FCO

FIELD CHANGE ORDER

Number: DEMPR-R001

Applicability: All DEMPR-AA and DEMPR-AB units should be upgraded to the minimum supported Revision level of "C1. Verify that all FS Stockrooms and SR17 have only revision "C1" or higher DEMPRs. All Thinwire Interim Revenue Ship (TIRS) Program DEMPRs that are not Revision level "C1" will require replacement. Replacing a Revision "B1" DEMPR (TIRS) with a Rev. "C1" unit does not require and reconfiguration of the network. This FCO implements ECO number DEMPR-ML002.

TIRS CONFIGURATION #1

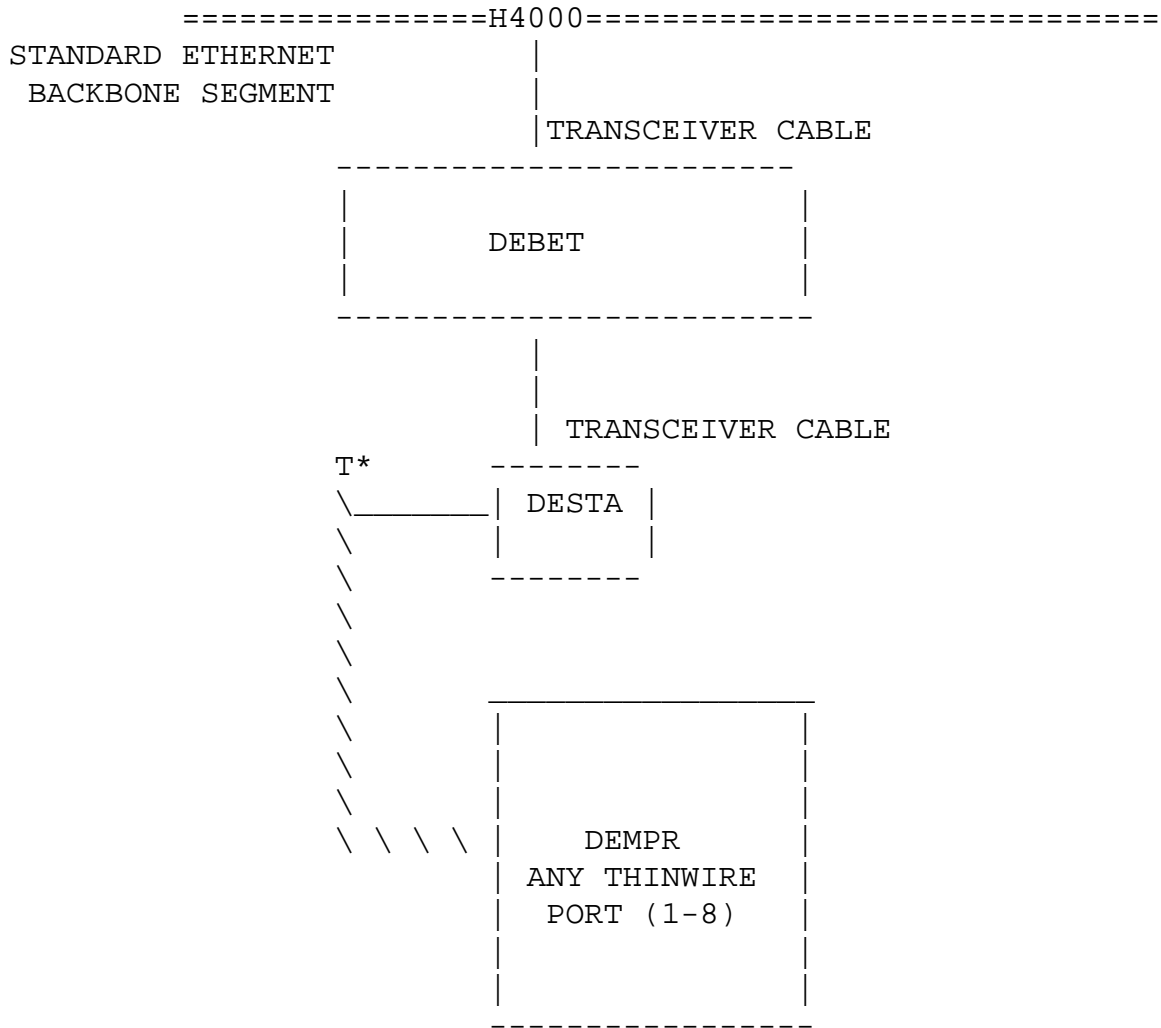
The following shows the Revision "B1" configuration, which is referred to as TIRS Configurations #1, #2, and #3, with its standard configuration for Revision "C1" DEMPRs'.

- o USES A DEMPR THINWIRE COAXIAL CABLE PORT AND DESTA TO CONNECT TO THE DEBET.
- o USES ANY ONE OF THE EIGHT DEMPR THINWIRE COAX CABLE PORTS.
- o HARDWARE REQUIRED: DEBET, ONE H4000, ONE DESTA, TWO TRANSCEIVER

CHANGING #1 TO A STANDARD CONFIGURATION

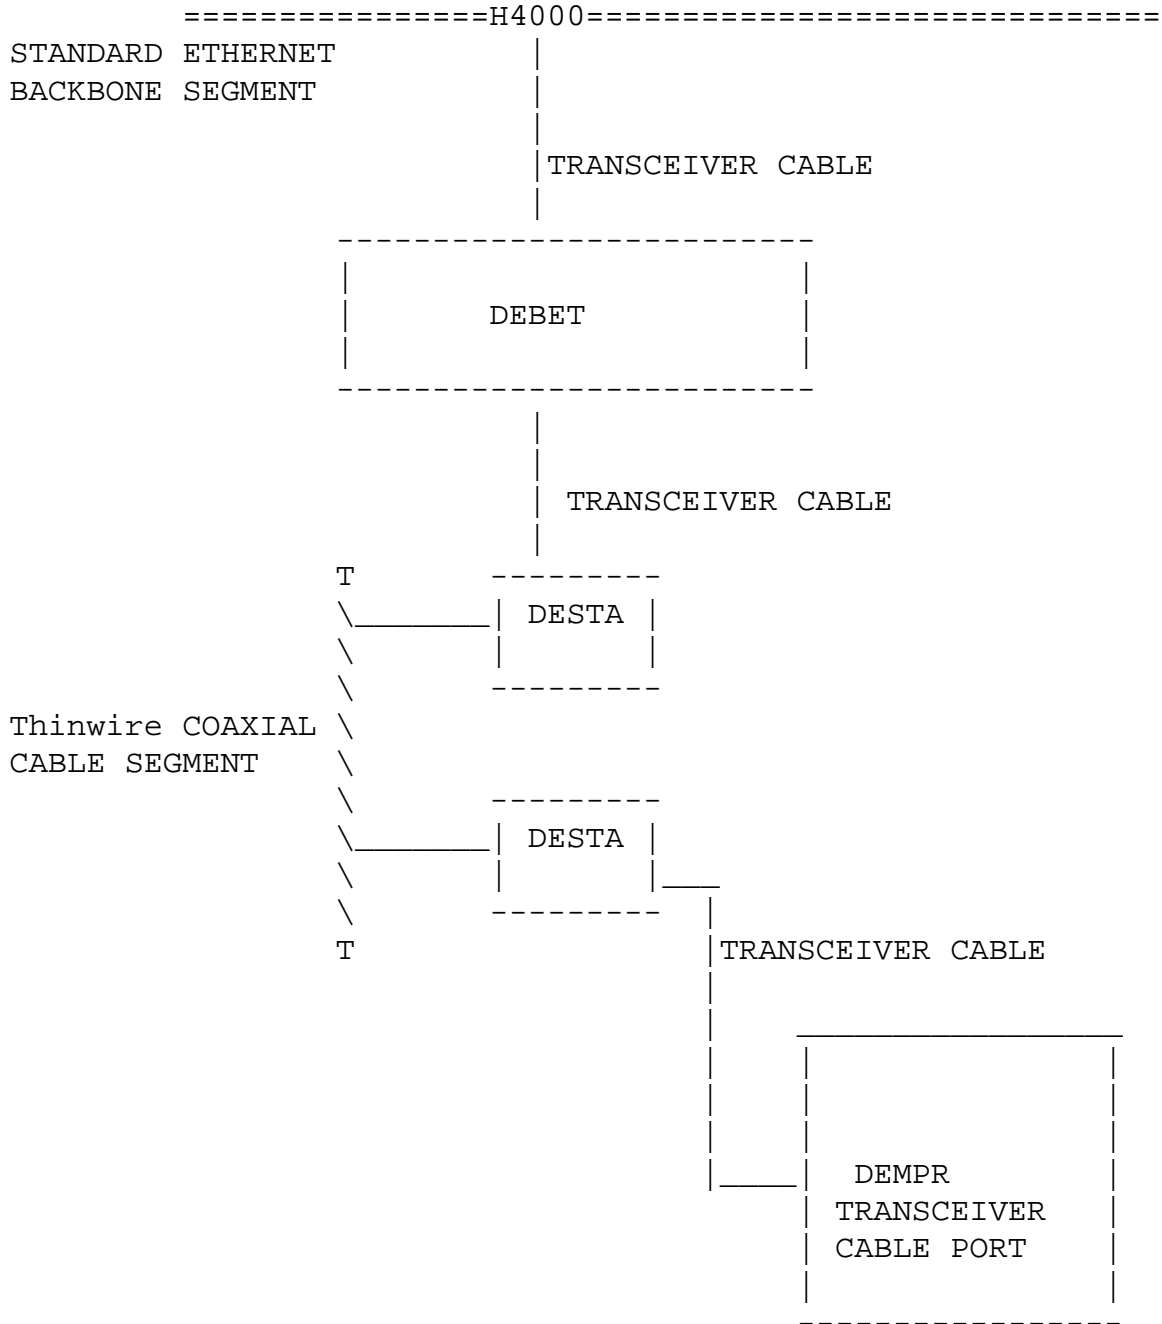
- o DEMPR is a Revision "C1" or higher.
- o DEBET, DESTA, and one transceiver cable are removed.

CHANGING #3 TO A STANDARD CONFIGURATION

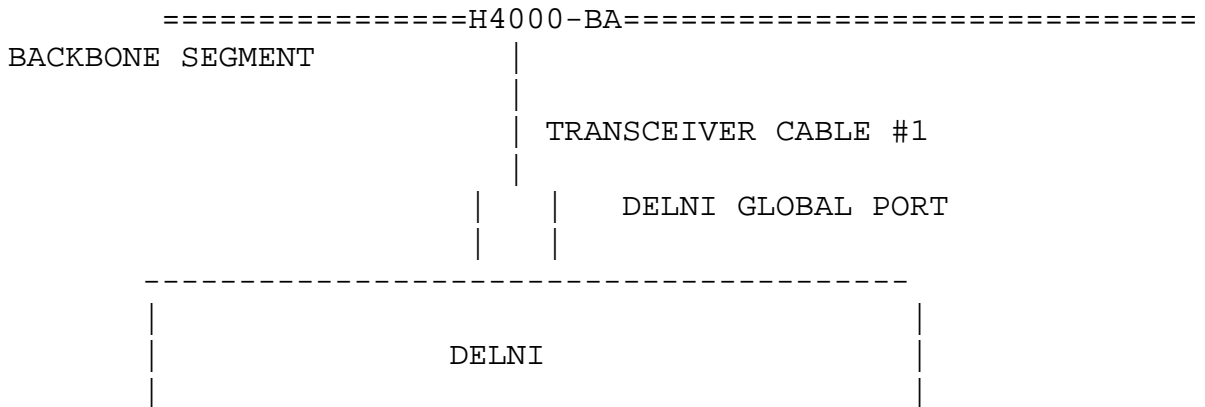
- o DEMPR is a Revision "C1" or higher.
- o The DEBET, Loopback Connector (on the DELNI global port) and one transceiver cable are removed.
- o The H4000-AA is replaced by a transceiver that does not have heartbeat... the H4000-BA. The transceiver used in this configuration cannot have heartbeat enabled.
- o The DELNI is configured in the global mode.

NOTES: None of the DELNI ports will have heartbeat/CPT. This will effect any device that requires heartbeat/CPT for normal operation.
 A longer transceiver cable may be required to attach the DEMPR directly to the H4000. Two similar type transceiver cables (802.3 or DEC Standard) may be concatenated to provide a longer length, DO NOT mix 802.3 with DEC Standard. The combined length of the two Transceiver cables #1 and #2 (see below) should not exceed 45 meters.
